From: drainage <drainage@midsussex.gov.uk>
Sent: 15 May 2026 16:39:27 UTC+01:00
To: "Andy Watt" <Andy.Watt@midsussex.gov.uk>
Cc: "drainage" <drainage@midsussex.gov.uk>
Subject: 2026.05.15 Re: DM/26/0572 - 26 Kennedy Avenue RH19 2DG

We have reviewed the additional information submitted by the applicant.

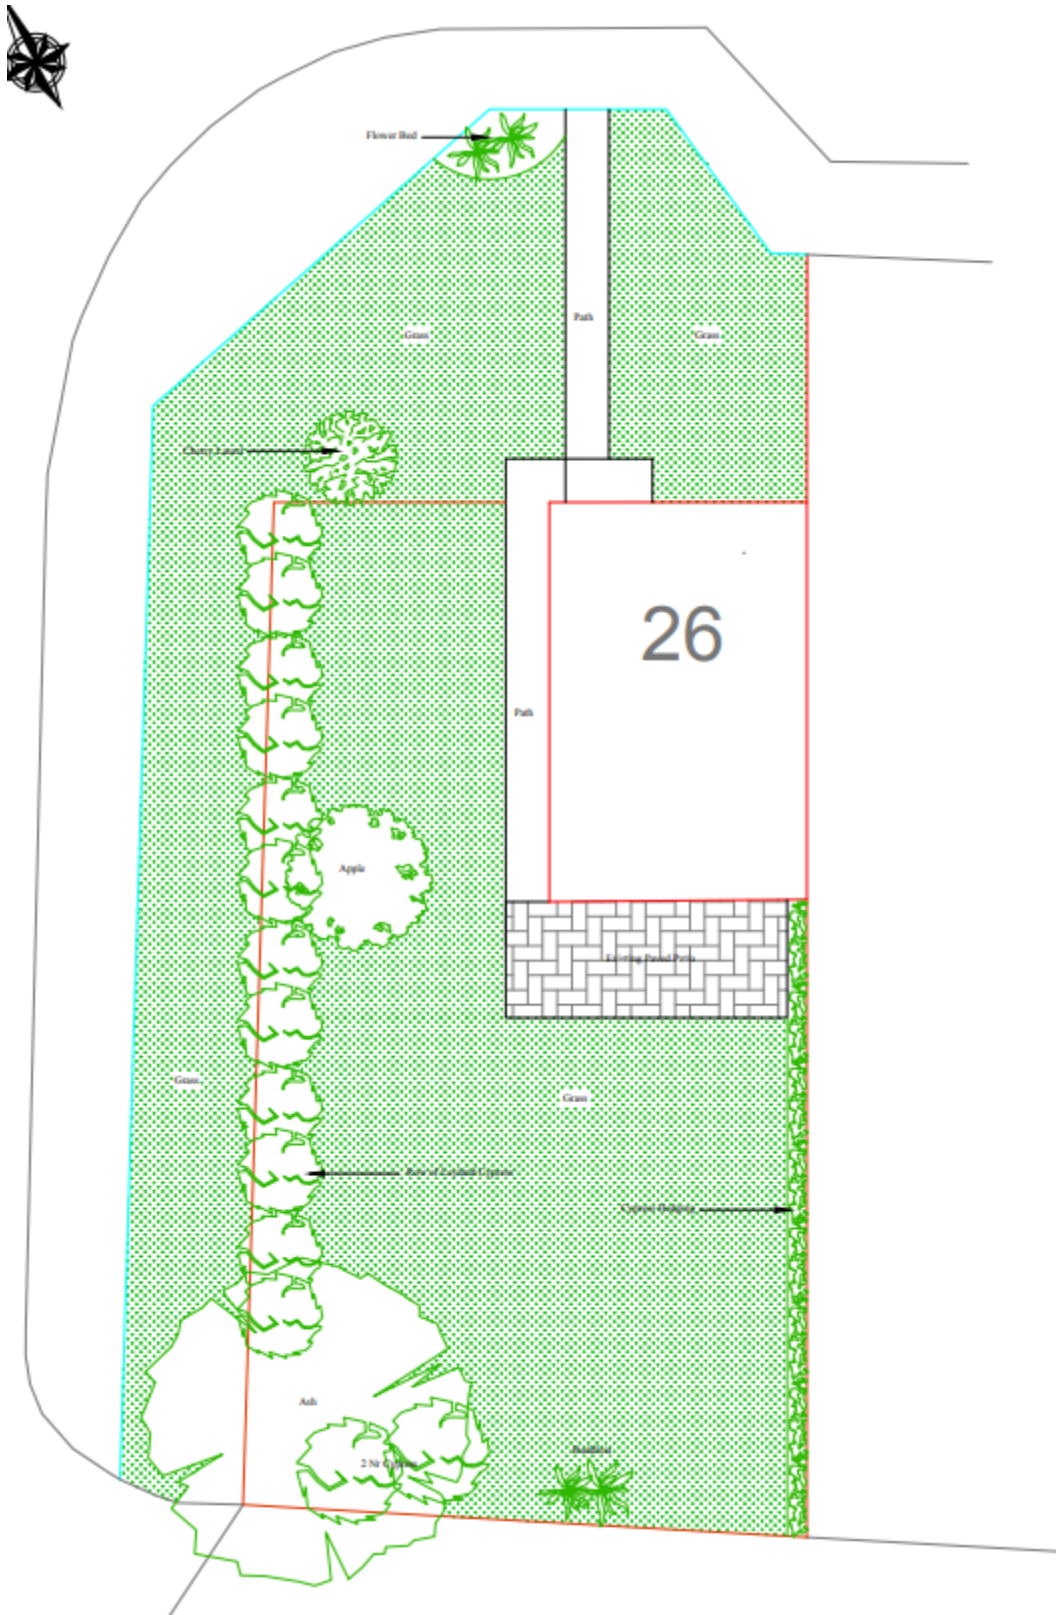
The site is currently predominantly permeable, and the proposal would increase the impermeable area (See existing block plan). Therefore, it is necessary to demonstrate that any discharge from the site will be appropriately restricted to the equivalent greenfield runoff rate in accordance with current policy requirements. No drainage calculations have currently been provided by the applicant to demonstrate this.

In addition, the applicant appears to be relying on an existing rainwater downpipe connection outside of the application boundary (see Application boundary plan below) (associated with No. 26), with no equivalent rainwater downpipe shown serving the proposed dwelling at 26A (see Proposed block plan with drainage). This raises concerns regarding future ownership, access, maintenance responsibilities of the drainage system.

Current MSDC guidance expects all SuDS features should be located within the application boundary.

- Drainage calculations demonstrating that the surface water drainage system has been designed to accommodate the 1 in 100-year rainfall event plus an appropriate allowance for climate change, together with a 10% urban creep allowance and a runoff coefficient (Cv) of 1.0 applied to all impermeable areas
- A management and maintenance plan
